60802 management

Analysis

Solution 1

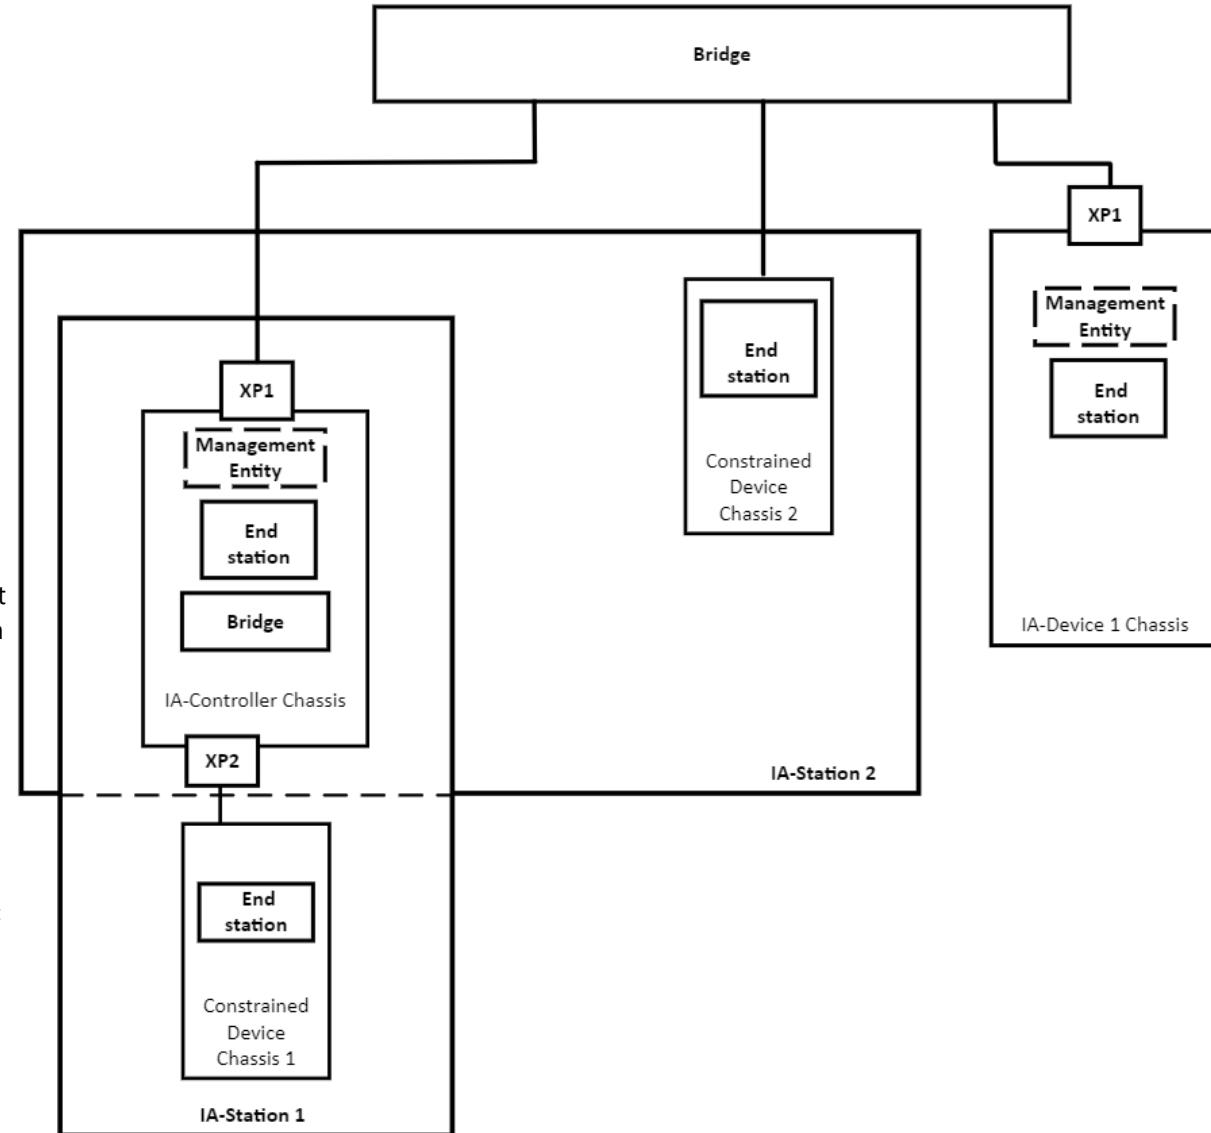
- Improve IA-Station definition
 - Today
 - 3.3.10 IA-station: material element or assembly of one or more end station components, and zero, one or more bridge components

- Note 1 to entry: IA-controllers and IA-devices are industrial automation functions of IA-stations
 - Proposal
 - 3.3.10 IA-station: material element or assembly of one or more end station components, and zero, one or more bridge components

- Note 1 to entry: IA-controllers and IA-devices are industrial automation functions of IA-stations.
 - **Note 2 to entry: An IA-station may be implemented in one or more chassis**

- Proposal for adding this section 4.3
 - After Figure 4, row 835
 - IA-Stations can also extend beyond one chassis, for example, as follows: One Functional Unit of the IA-Station could be an IA-controller within its chassis. Another chassis could contain a constrained device which cannot become an IA-station by itself, due to hardware resource limitations. The management entity of the IA-controller can be shared among different IA-stations. Each constrained device must adhere to all IA-station stream requirements applicable to its configuration domain.'

- Add also Figure on the right here
 - Security considerations – potentially as a Note
 - All security management is insured to the constrained devices, by following 5.5.4.2. Secure management exchanges using the management entity for each such formed IA-Station

Solution 2

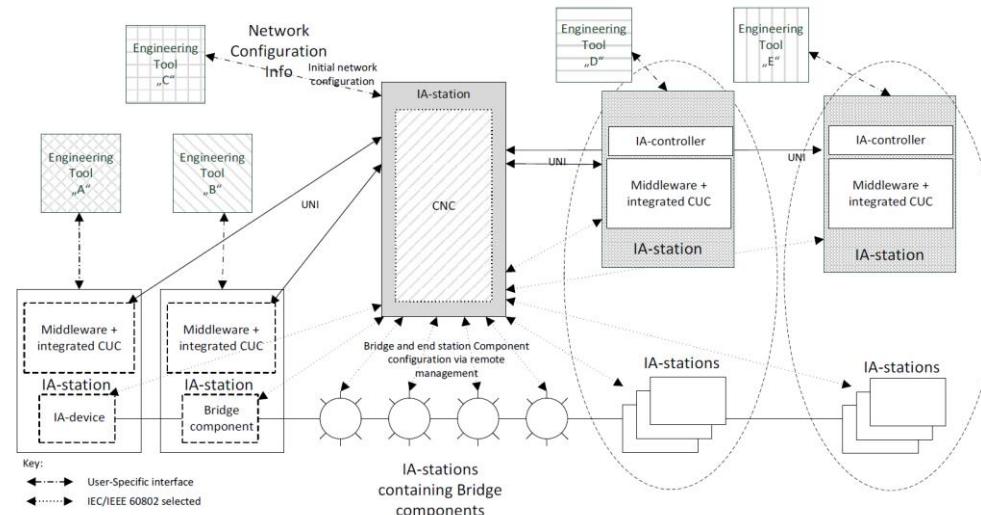
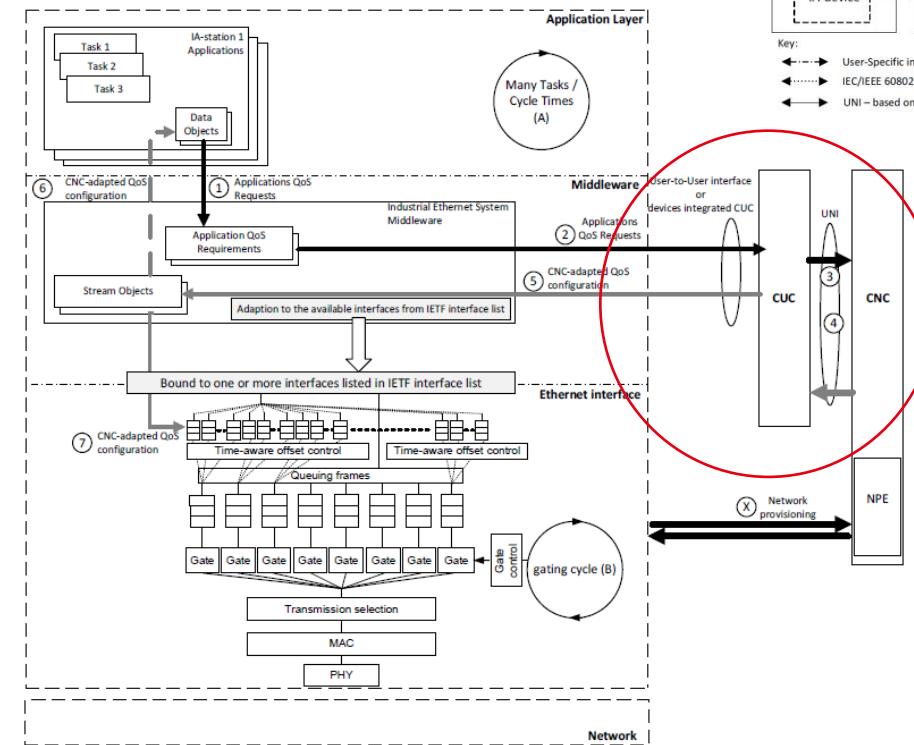
- 60802's centralized management model
 - The CUC takes its inputs from an engineering tool
 - Uses the « UNI » to negotiate the Streams with the CNC
 - Lesser role than in 802.1Q(dj)
 - The CNC configures the end stations and bridges (= IA-stations)
 - Bigger role than in 802.1Q(dj)

Solution 2

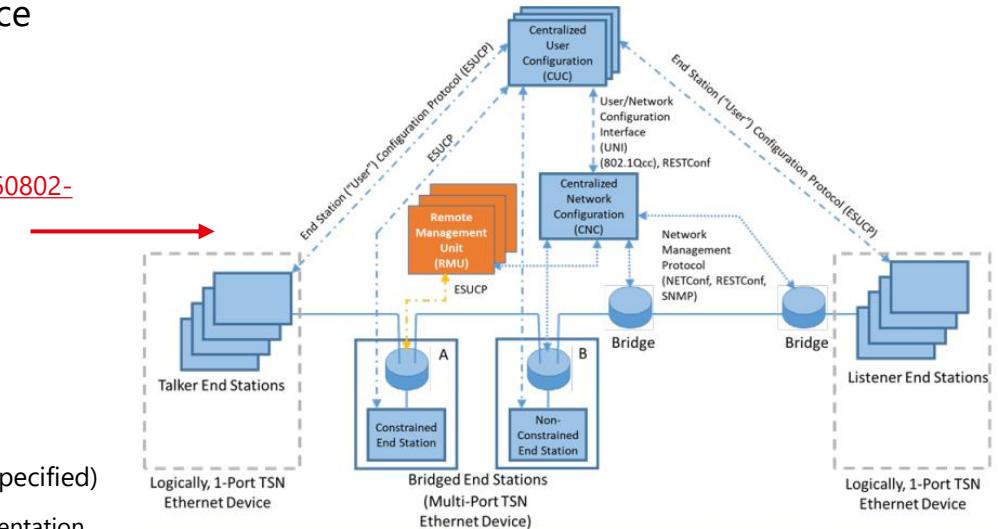
- Possible way out... (nothing new...) – introducing a « specific » (**but interoperable**) configuration domain that relies on a « basic » Network Management conformance class (vs. « full » in a 60802-compliant configuration domain)

- CUC (à la 802.1Q(dj)) used as an access gate for the management of the specific domain
 - Conforms to cyber-security related requirements of 60802
 - Allows an additional, Qcc/Qdj-conformant CUC-based network management concept (not to be specified)

- Where the CUC handles the specific-domain management protocol and information model implementation (e.g., through the « specific » middleware)
- Stations can still be managed from 60802 TSN configuration domain (CNC)

- Through the CUC
 - By keeping an interoperable information model
 - 2 conformance classes
 - In a 60802 domain -> Full : 60802 managed objects + NETCONF + YANG

- In an independent domain -> Basic : subset(*) of 60802 managed objects
 - Same philosophy as in 802.1Q
 - Interoperability with 60802 configuration domain kept
